<b>Staff Report</b>    <b>Zoning &amp; Land Regulation Committee</b>	<u>Public Hearing:</u> <b>April 22, 2025</b>		<b>Petition 12133</b>
	<u>Zoning Amendment Requested:</u> <b>AT-35 Agriculture Transition District TO RR-4 Rural Residential District</b>		<u>Town, Section:</u> <b>SPRINGDALE, Section 17</b>
	<u>Size:</u> <b>8 Acres</b>	<u>Survey Required:</u> <b>Yes</b>	<u>Applicant:</u> <b>KELLY CONNOR (GINTHER)</b>
	<u>Reason for the request:</u> <b>Creating two residential lots</b>		<u>Address:</u> <b>EAST OF 9204 GEM VIEW ROAD</b>

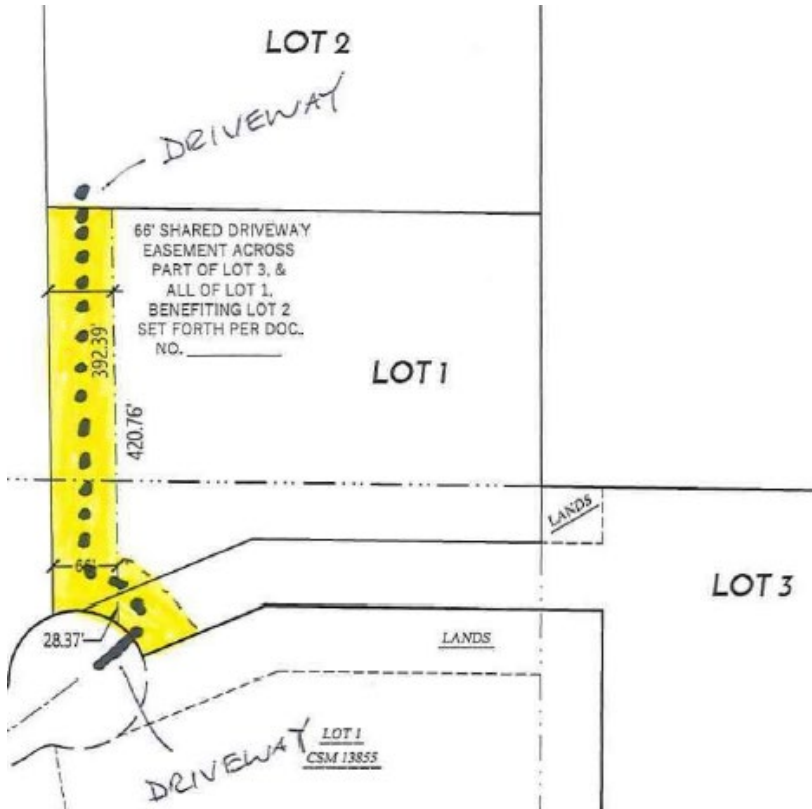
**OBSERVATIONS:** The lots meet most county ordinance requirements for lot size and configuration. The proposal would provide the required 66 feet of lot width and road frontage on the agricultural Lot 4. It would provide access to Lot 2 (which has no road frontage) by a shared access easement across both Lot 1 and Lot 3. In order to have a lot without frontage, the adjacent lot must have a 66-foot wide driveway easement and the agreement must meet specific requirements under Dane County Land Division Ordinance Section 75.19(8). This was discussed with the applicants previously and options were provided to meet ordinance requirements.

Because Lot 1 (where the driveway would be located) does not have 66 feet of road frontage, the CSM will need to be adjusted to either (a) expand the access easement on Lot 3 to include that lot's entire 66 feet of frontage, and locate the driveway entrance within Lot 3 or (b) modify Lot 1 so that it has 66 feet of frontage (this would require reducing Lot 3's frontage; a minimum 30 feet of frontage is required in this case).

**STAFF RECOMMENDATION:** As noted above, there are a couple of ways the applicants can address the lot layout and driveway access requirements of the Dane County Chapter 75 land division ordinance. Lots 1 and 3 could be reconfigured slightly so that the entire access easement is on Lot 1. Alternately, if the lot layout remains as proposed, another workable solution would be to expand the easement and construct the driveway as shown below:

1. The layout of the lots shall meet the Shared Access easement requirements in s.75.19(8) of Dane County Land Division Ordinance.
2. A deed restriction shall be recorded on proposed CSM Lot 4 (current tax parcel 0607-173-9051-0) stating the following:
  - a. Lot 4 (zoned AT-35) shall have no further buildings or further land divisions.
3. A deed notice shall be recorded on Lots 1-3 of the proposed CSM (current tax parcel 0607-202-8485-0 and part of tax parcel 0607-173-9051-0) stating the following:
  - a. Further land divisions are prohibited. The housing density rights for the original Ginther Family Limited Partnership farm have been exhausted per the Town Comprehensive Plan density policies.
